APPENDIX A – RESPONSE TO INFORMATION REQUEST

Table 1: Response to LMCC Comments

Figure 13: Elevations of proposed Pylon Signs to be 10 metres tall. *BN Group Architects*

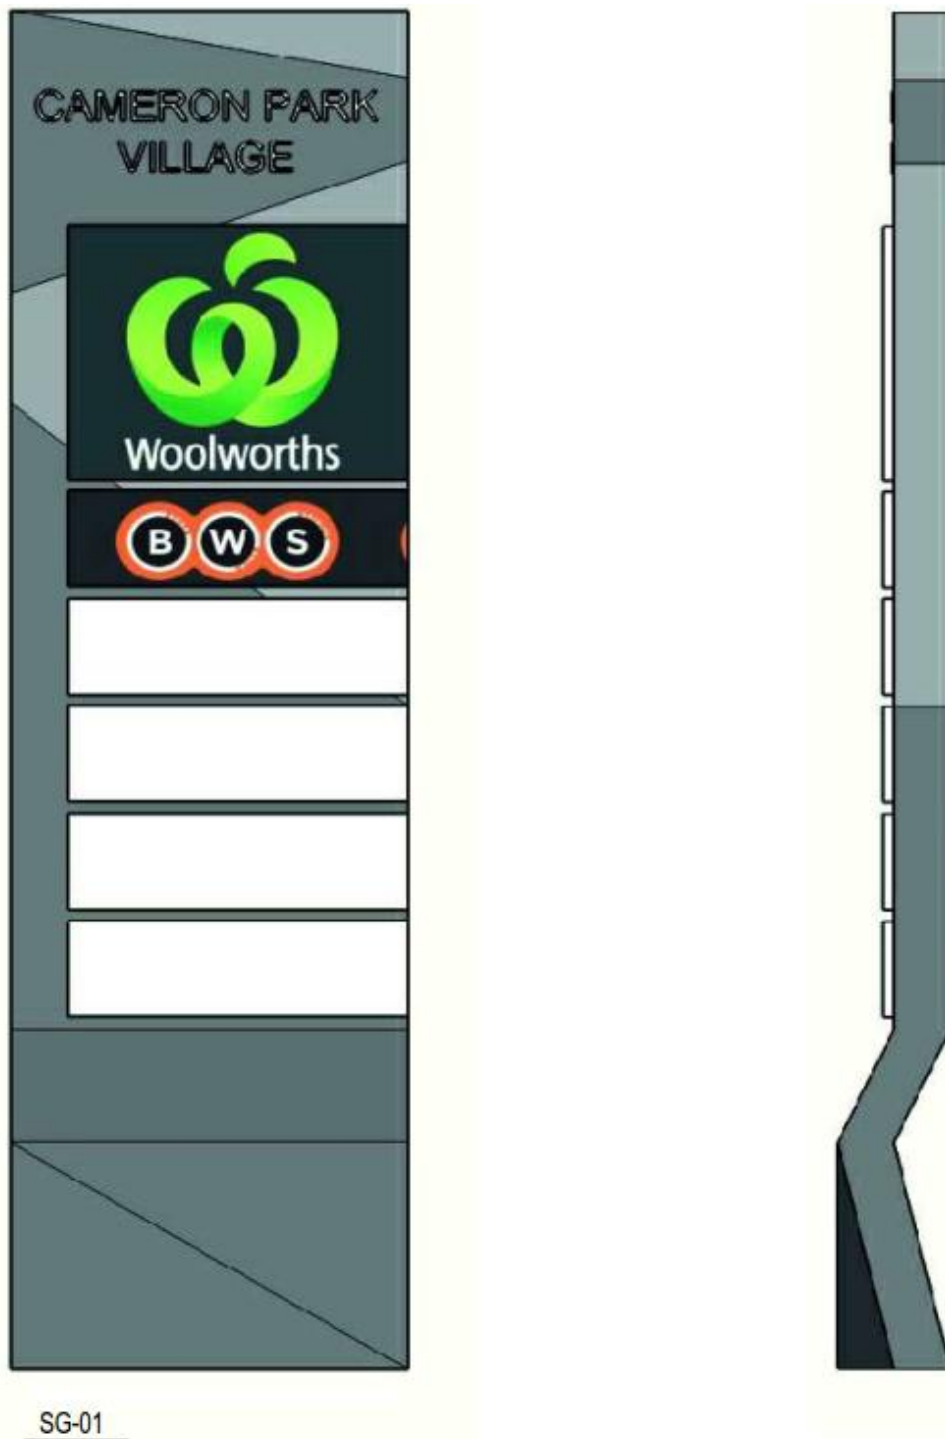
| LMCC Comment | Response |
|---|---|
| <p>1. Scenic Value: Having regard to Section 2.2 (Scenic Values) of Development Control Plan (DCP) 2014, Council's Landscape Architect, Robyn Pollock, has reviewed the proposed development and submitted Visual Impact Assessment (VIA) and advised the development is zoned B2 (Local Centre) where the legibility of the development within the residential setting is an important consideration. There is information omitted from the photomontages that do not give a full indication of the visual impact. The concerns are:</p> <ul style="list-style-type: none"> a) The photo montages do not show future development fronting Portland Drive - the proposed development impacts along this road is indeterminate. b) The pylon signage located in the VIA dominates the two prominent corners and there is no accompanying information regarding size, materials etc. c) The pylon sign shown along the southern George Booth Drive frontage is not assessed for visual impact and is not supported. d) The far western 'future development site' will require significant retaining to achieve buildability on this site. The visual impact of these retaining walls is to be included in the VIA. e) The retaining proposed adjoining Tramway Drive proposes 1000mm planted edge to screen a 2500mm plus wall. This is too narrow to support vegetation and not supported. | <p>Provided in Appendix F is an addendum to the Visual Impact Statement prepared by BN Group. Relevant to the specific comments by Council, the following response is provided:</p> <ul style="list-style-type: none"> a) The architectural plans provided within Appendix D show the elevation of T22 which is proposed to present to the corner of Portland Drive and Northridge Drive (refer to eastern and northern elevations). <p>As identified within Sections 6.1 and 5.4.1 of the SoEE, the subject site contains a zoning anomaly, with two (2) small portions of the site along its eastern edge (approximately 15m wide) being zoned R3 Medium Density Residential which currently prohibits commercial development. Therefore at this time and until the zoning anomaly is rectified, any commercial development would be required to be set back approximately 15m from Portland Drive, which is not a desirable urban form outcome. The portions of the site affected by the zoning anomaly are contained within proposed Lots 3 and 4.</p> <p>For the purposes of the current DA, proposed Lots 3 and 4 are to be landscaped (refer to the landscaping plans provided within Appendix G of this submission).</p> <p>Future development of proposed Lots 3 and 4 is subject to a separate Development Application. The design of Lots 3 and 4 provides flexibility in respect of the zoning anomaly, noting that at the time a future application is made, it is possible that the zoning anomaly will have been rectified (noting that Council are currently progressing a rezoning application that will resolve this issue). Notwithstanding, if the anomaly has not been rectified, the application will be subject to separate assessment against Council's DCP. It is considered that proposed Lots 3 and 4 are of a suitable size and shape to facilitate future development design that will contribute to the Woolworths shopping centre as well as provide appropriate street edge treatment along</p> |

| LMCC Comment | Response |
|--|--|
| | <p>Portland Drive.</p> <p>b) Details of proposed pylon signage are provided on the 'Signage Details' plan provided within Appendix D of this submission.</p> <p>As requested by Council staff, the pylon signs have been reduced in height to 10m high. It is considered that the pylon signage is of an appropriate scale commensurate with the overall proposed Cameron Park Village development.</p> <p>c) Both pylon signs at the George Booth Drive frontage (at the south east and south western corners of the site) are illustrated in 'View 1 Proposed George Booth Drive looking East' (p14) of the VIA. It is considered that the proposed signage is consistent with the scale of the proposed development.</p> <p>d) This matter is addressed within the addendum to the Visual Impact Statement provided within Appendix F of this submission. The end user of the far western future development site is not known at this time and the site could be developed in a range of ways that may or may not require significant retaining to Tramway Drive.</p> <p>Accordingly, the future development site is proposed to be landscaped which will remain in place until a future development application is lodged. At that time the visual impact of any retaining will be considered. Until that time it is considered that the landscaping proposed is suitable in terms of visual impact considerations.</p> <p>e) This matter is addressed within the revised engineering and landscaping plans provided within Appendices E and G of this submission. The 1000mm planted edge has been increased in size to 3500mm, which is considered adequate to support vegetation planting.</p> |

– Pylon sign information was included in the Architectural package on Drawing A100.91 [DA-B], however in recognition of Council's comments, the sizes of the Pylon signs have been reduced, and the plan has been amended accordingly.

Figure 2 – Option 10.3.

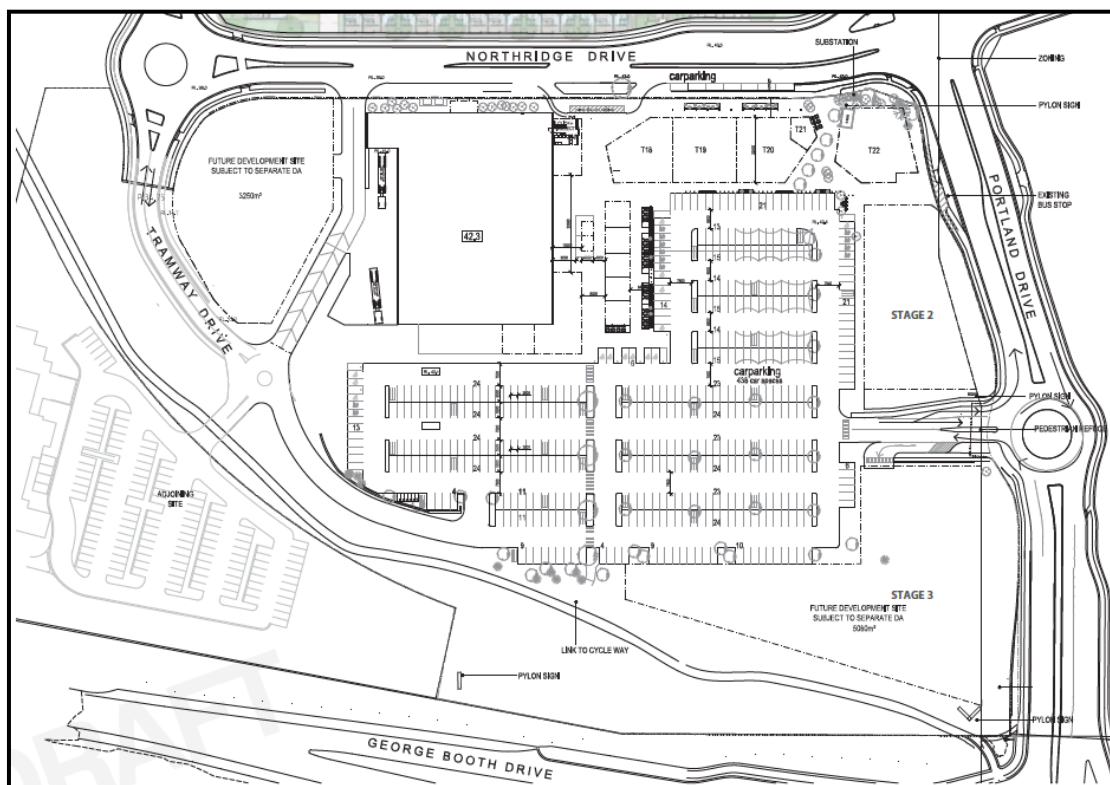
Council's RFI identifies Option 10.3 as being the most suitable location for the loading dock (this option shifts the loading dock to the west of the supermarket and utilises a 1 way flow of large delivery vehicle traffic from Northridge Drive through to a roundabout on Tramway Drive), as shown below.

As a result of the analysis undertaken by the abovementioned specialists, the proponent is strongly of the position that option 10.3 is a poor outcome for the following reasons:
